CHANGE ORDER

PROJECT:
Meadowdale Beach Park and Estuary
Restoration Project
PW-002-21SB

CHANGE ORDER NO: 6

CONTRACT FOR: Park Improvements
and Estuary Restoration

Meadowdale Monitoring Point Layout

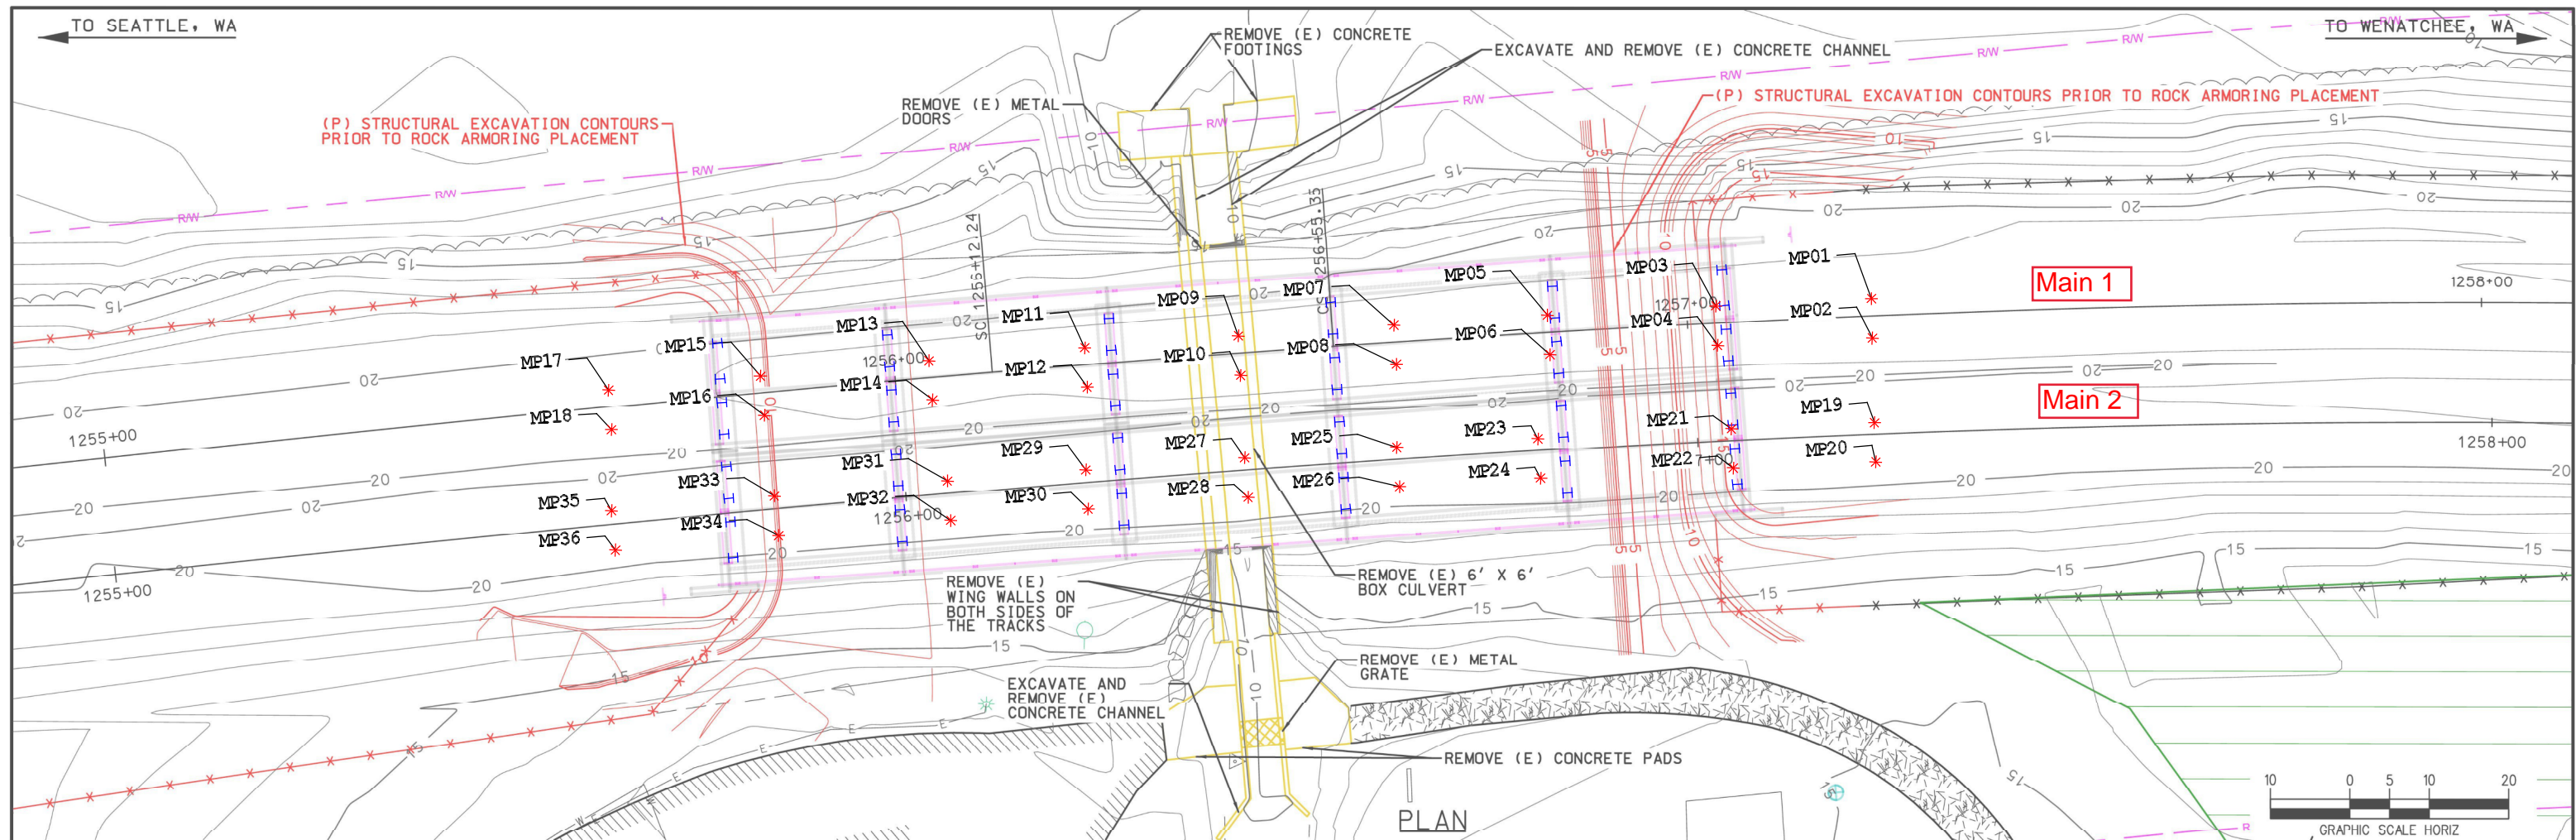
Improved Track Monitoring Plan

Track Monitoring – Strider will add prisms every 10' on each rail of each track (both mains) between current prisms for additional data points to verify any track movement. In addition, Strider's Site Superintendent will utilize fixed positions (such as H-pile, posts, trees, etc.) to spot check and verify distances to determine whether survey is capturing all track movement. When movement occurs, a monitoring plot showing the location will be provided in the communication described below. A sample is attached to this plan. If track tamping occurs to repair a track that has shifted, a new baseline for the monitoring will be established.

Sheet Pile Alignment – Strider's subcontractor, Greyrock Drilling, will modify the alignment of the sheet piles slightly (~3.5") closer to Main 2 from Main 1 track in order to avoid driving against the ties.

Driving Method – In addition, Greyrock will avoid "burying the vibratory hammer" in the ground. In order to accomplish this and still maintain the correct top of pile elevation, it may be required to cut the tops of the sheets off. A separate fire prevention plan will be submitted to cover this portion of work. If this happens, care will be taken to ensure the required tip elevation is still achieved. Lastly, Strider will provide manpower/pneumatic tamping equipment as necessary to ensure ballast pockets are filled with each pile driven to help minimize track movement.
